Subject: Dresden Station Units 2 and 3
Quad Cities Station Units 1 and 2
NUREG 0737 Items II.F.1.4, 5 and 6
Containment Pressure, Water Level and
Hydrogen Monitoring
NRC Docket Nos. 50-237/249 and 50-254/265

ATTACHMENT
COMMONWEALTH EDISON COMPANY

Response to NRC Request
For Additional Information concerning
NUREG 0737 Items:

- II.F.1.4 Containment Pressure Monitor
- II.F.1.5 Containment Water Level Monitor
- II.F.1.6 Containment Hydrogen Monitor

FIG 1

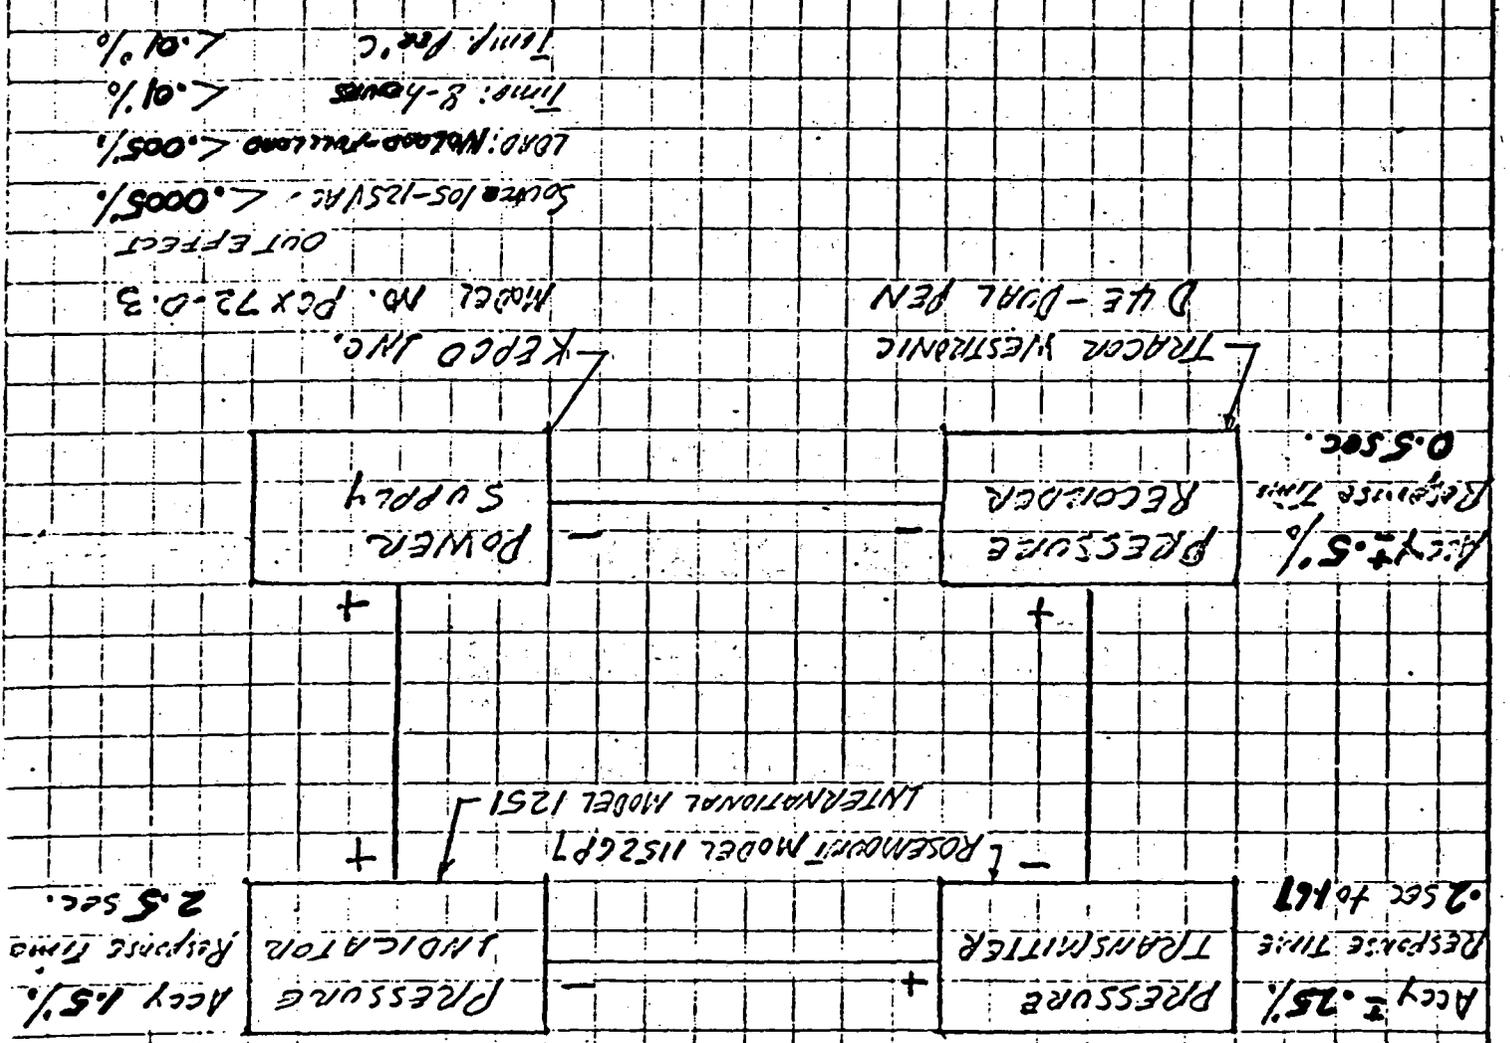
(2a) See the attached block diagram Fig. 1.

(2b) The following is a list of parameters which affect the accuracy of each module:

- a. Stability \pm 0.25%
- b. Total temperature effect \pm 1.1%
- c. Seismic performance \pm 0.25%
- d. Radiation performance \pm 0.70%
- e. Power supply effect \pm 0.005%
- f. Calibration error \pm 0.5%

(2c) By combining the uncertainties within each module and then combining the uncertainties of each module within a loop by the square root of the sum of the squares method, the following overall loop uncertainties were derived:

- a. Transmitter to indicator: 7.06% error
- b. Transmitter to recorder: 5.51% error

(2d) The following is the time response for each component:

- a. Instrument tubing 0.1 sec. (estimate)
- b. Transmitter 0.2 sec. to 1.67 sec. adjustable (time constant)
- c. Indicator 2.5 sec. (maximum response time)
- d. Recorder 0.5 sec. full scale (step response)

(2e) Under the assumption that the transmitter time constant is set at its minimum value of 0.2 seconds, then the system response time to the recorder should be less than 1 second. Summing the response times of the components gives a system response time of less than 3 seconds.

FIG 2

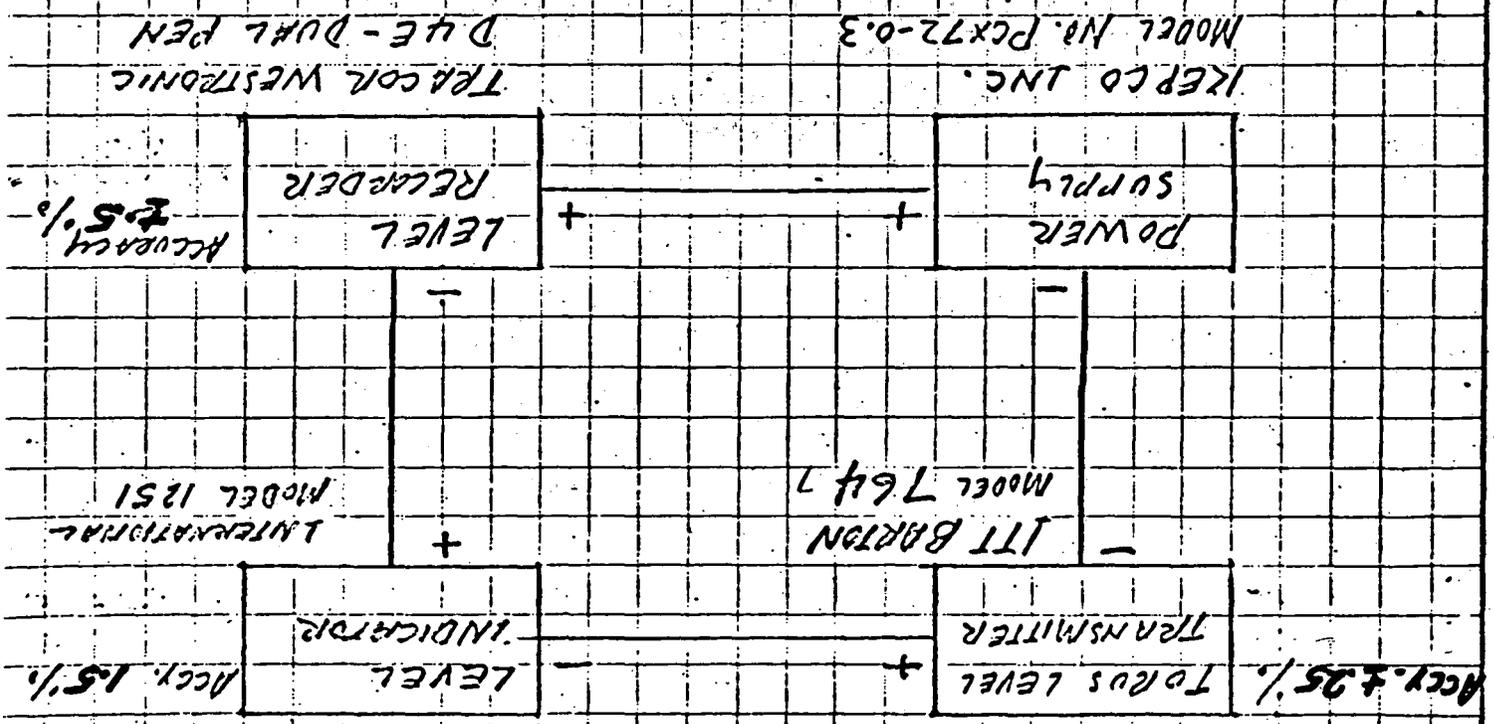
- (3a) See the attached block diagram Fig. 2.
- (3b) The following is a list of parameters which affect the accuracy of a module:
- a. Thermal effect
 - b. Radiation effect
 - c. Drift effect
 - d. Power supply effect
 - e. Calibration error

The overall effect on a module by these parameters is estimated to be + 10%. However, the effect of each parameter is not precisely known.

- (3c) By combining the uncertainty of each module in a loop using square root of the sum of the squares method, the following overall loop uncertainties were derived:
- a. Transmitter to indicator: 9.4% error
 - b. Transmitter to recorder: 8.3% error

DRESDEN AND QUAD CITIES STATIONS NUREG 0737 Item II.F.1.6 HYDROGEN MONITORING

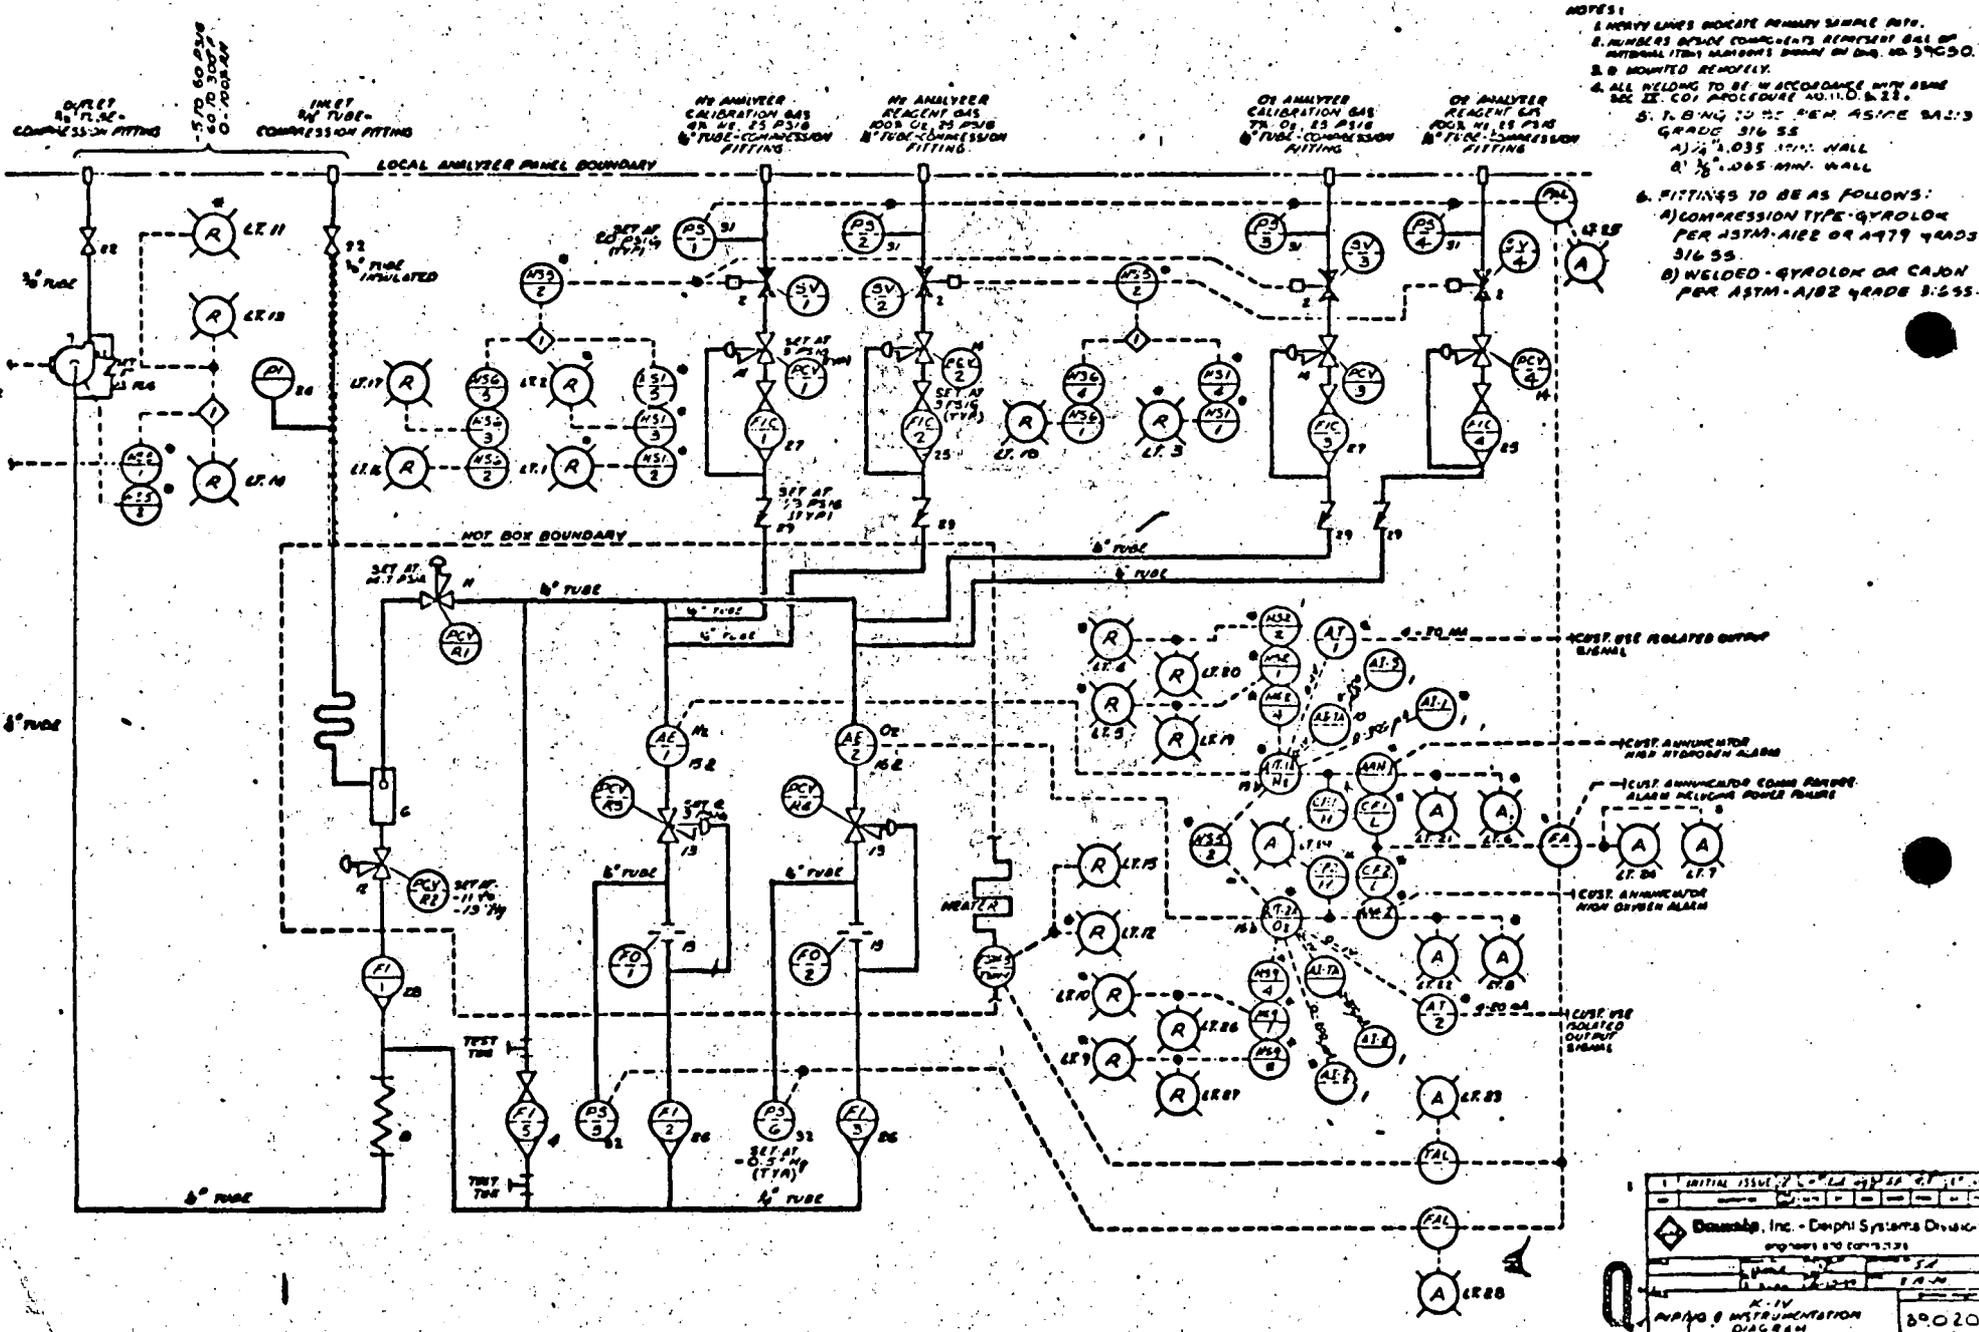
- (4a) In lieu of a block diagram, we have included a system diagram for your information.
- (4b) The Comsip Hydrogen Monitoring System errors are as follows:
- a. \pm 2% error in reading due to calibrated gas.
 - b. \pm 1% error in reading due to analyzer electronics (electronics located outside of harsh area).
 - c. \pm 1% error in reading due to flow variations.
 - d. \pm 1/2% error in reading due to transducer (located outside of harsh area).
 - e. \pm 2% error due to long term drift.

Although the square root of the sums of these errors is only 3.2% error, Comsip believes that this value is low and that a conservative value of 4.5% should be used for the signal output of the system.

- (4c) Therefore, based on a 4.5% error and the accuracy of the indicator, the combined error is estimated to be 4.7%.
- (4d) There will be four hydrogen monitor intake ports on each of the two headers in each containment. The intake ports on each header will be located at four elevations approximately equidistant from each other. The headers will be on opposite sides of the reactor pressure vessel inside the containment. A globe valve on each intake port will allow throttling. The valves will be set to provide approximately equal flow into each intake port.
- (4e) There are no obstructions which would prevent hydrogen from reaching the intake ports quickly.
